TENNESSEE VALLEY AUTHORITY

SEQUOYAH NUCLEAR PLANT (SQN) - ADDITIONAL INFORMATION FOR SQN UNIT 2  
HYDROGEN ANALYZER SAMPLING VALVE RELIEF REQUEST

ALTERNATE TESTING FOR UNIT 2 HYDROGEN ANALYZER SAMPLING VALVES  
FSV-43-201, -202, -207, -208

Revised Relief Request PV-15 with Revised  
Appendix C to SQN's In-Service Valve Test  
Program (SQN Final Safety Analysis  
Report, Section 6.8

## HYDROGEN ANALYZER SYSTEM SCHEMATIC

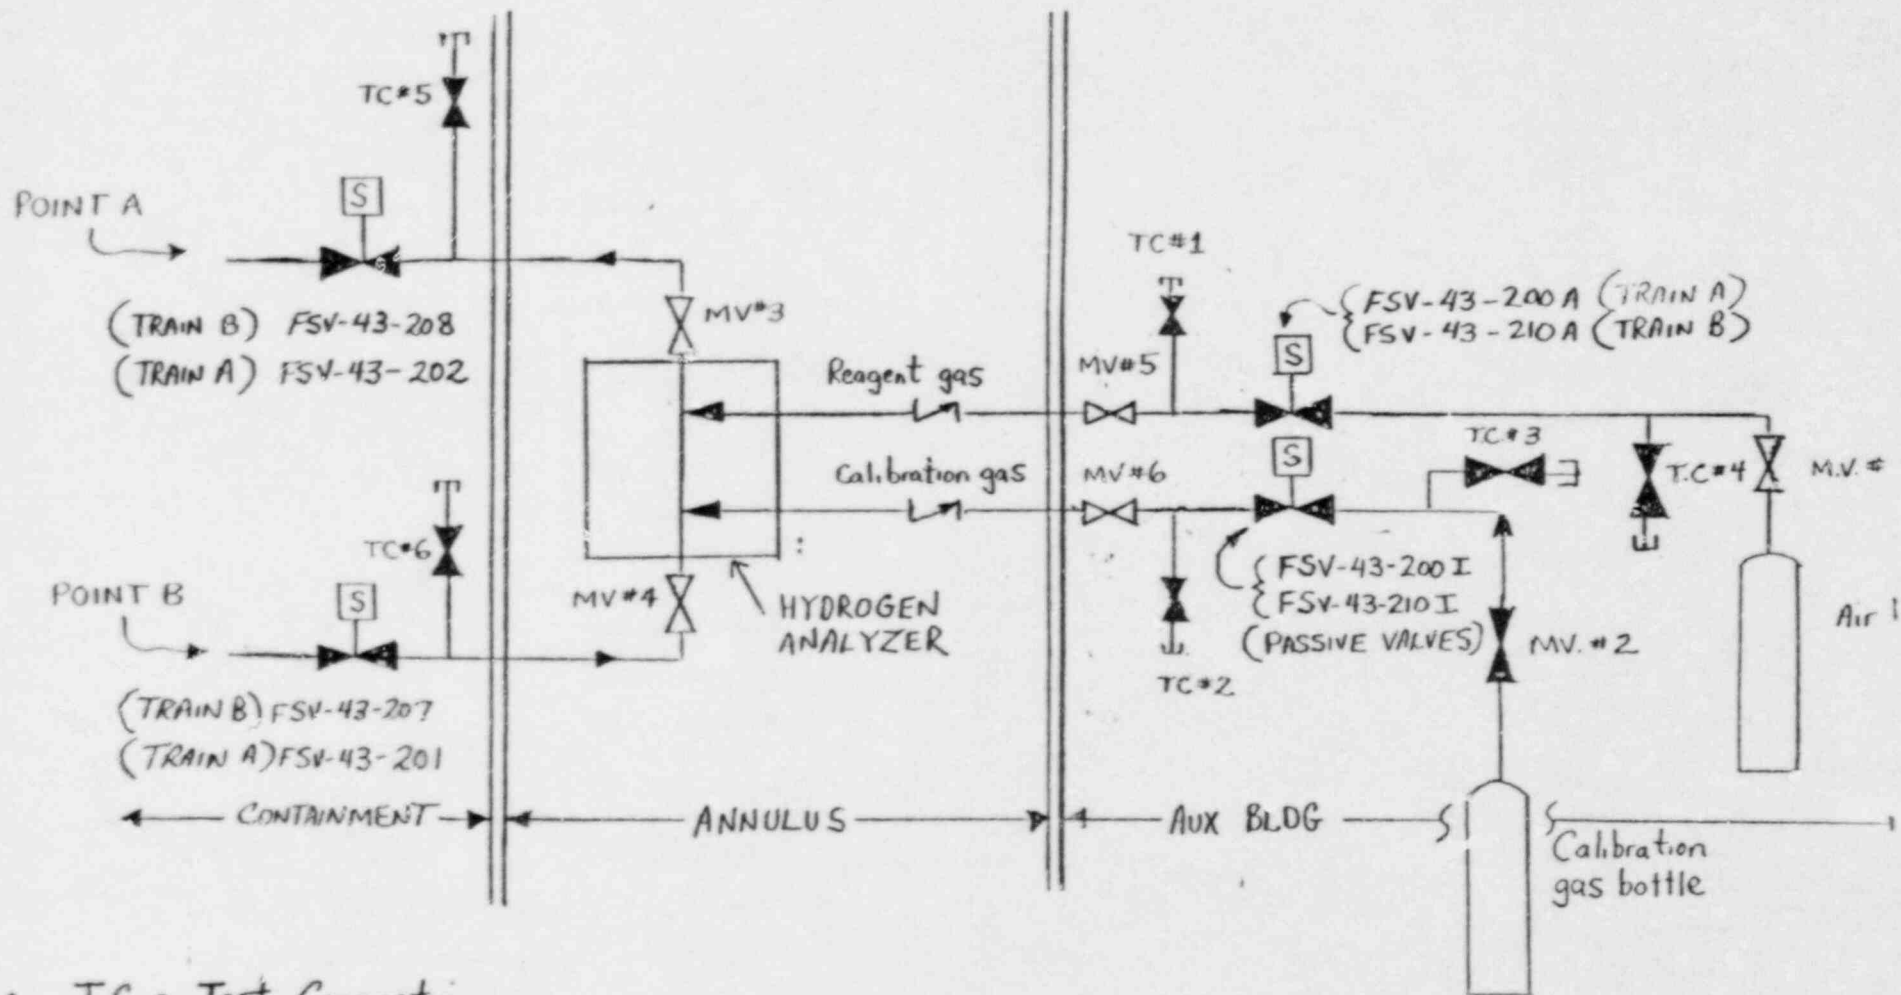
In lieu of a visual observation requirement, SQN requested relief to perform an alternate pressure test to verify proper operation. The following steps provide a simplified description of SQN's alternate test methods. This alternate test method will be incorporated into SQN's Surveillance Instruction (SI) 166.4 for testing the subject valves during unit 2 restart (before mode 2).

1. FSV-43-208

- a. Attach test rig with air supply to point A.
- b. Close manual valve #3.
- c. Open Test Connection (TC) #5.
- d. Pressurize test rig to 13 PSIG.
- e. Open FSV-43-208 and verify a pressure drop.
- f. Close FSV-43-208 and verify test rig pressure returns to 13 PSIG.
- g. Verify test rig pressure remains steady at 13 PSIG.
- h. Remove test rig and return valves to normal position.

2. FSV-43-207

- a. Attach test rig with air supply to point B.
- b. Close manual valve #4.
- c. Open TC #6.
- d. Pressurize test rig to 13 PSIG.
- e. Open FSV-43-207 and verify a pressure drop.
- f. Close FSV-43-207 and verify test rig pressure returns to 13 PSIG.
- g. Verify test rig pressure remains steady at 13 PSIG.
- h. Remove test rig and return valves to normal position.

The train A valves will be tested in a similar fashion as the train B valves.
